**From:** Sawyer, Michael B. - DPW  
**To:** Son, Joshua L. - PDR  
**Cc:** Helmboldt, Jakob C. - DPW; Bridewell, Travis A. - DPW; Mawby, Doug - DPW  
**Subject:** RE: Monroe Park - Laurel Street Event Venue  
**Date:** Thursday, March 23, 2017 11:56:25 AM  
**Attachments:** image001.png

TENT LAYOUT DIAGRAM  
APRIL 2017

MONROE PARK  
CONSERVANCY

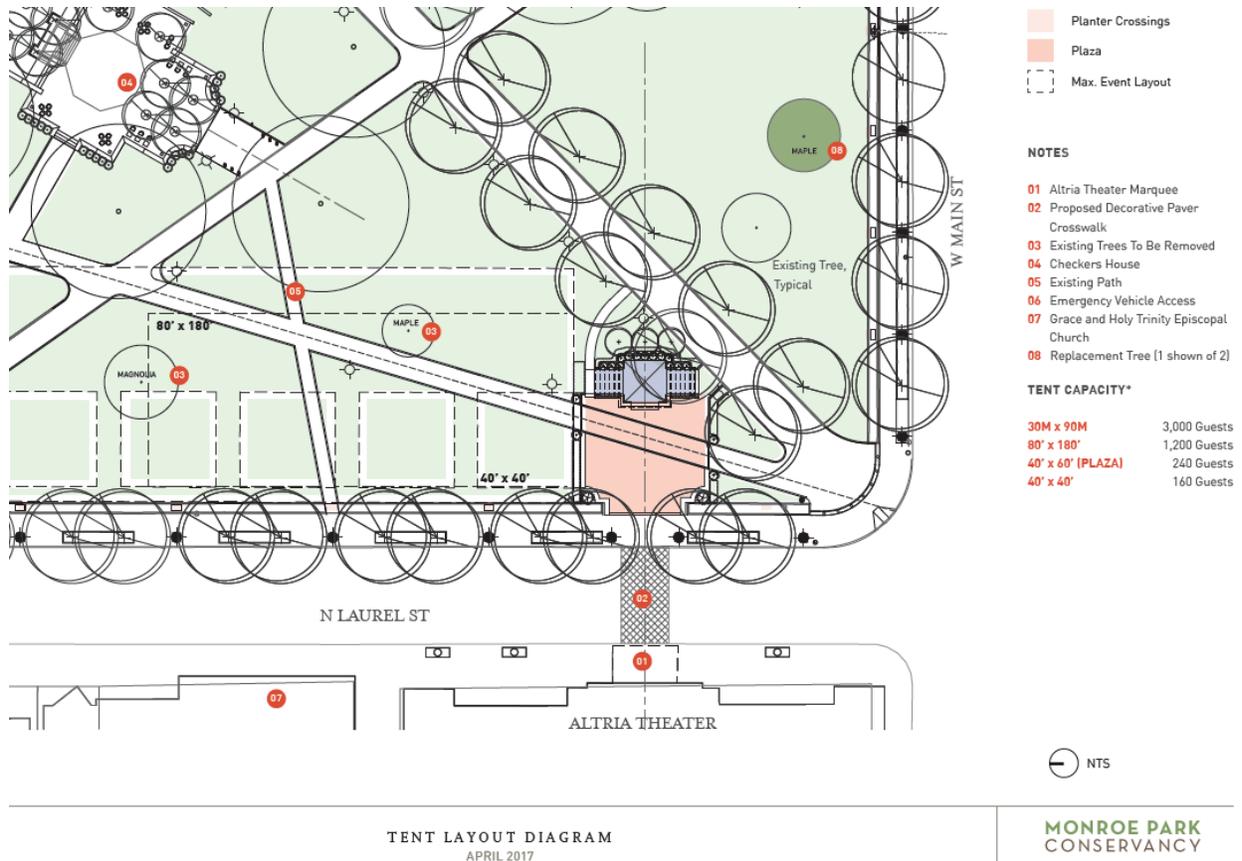
It is well within the intersection influence area of the existing traffic signal of Main and Laurel. We cannot support pedestrians crossings inbetween parked vehicles and inbetween vehicles waiting at the traffic signal. We cannot support removing additional parking in the area of the crosswalk and the additional parking that would need to be removed to provide adequate sight distance.

From an architectural perspective, this plan has merit; however, the practical use of the architect's desire lines are problematic from a pedestrian safety and parking perspective.

In reviewing plans, I was notified that their proposal calls for a mid-block crossing between the proposed project site and the Altria theatre, what are your initial thoughts?

The orientation should be towards the existing signalized crossing though landscaping etc. where gaps and pedestrian countdown signals exist.
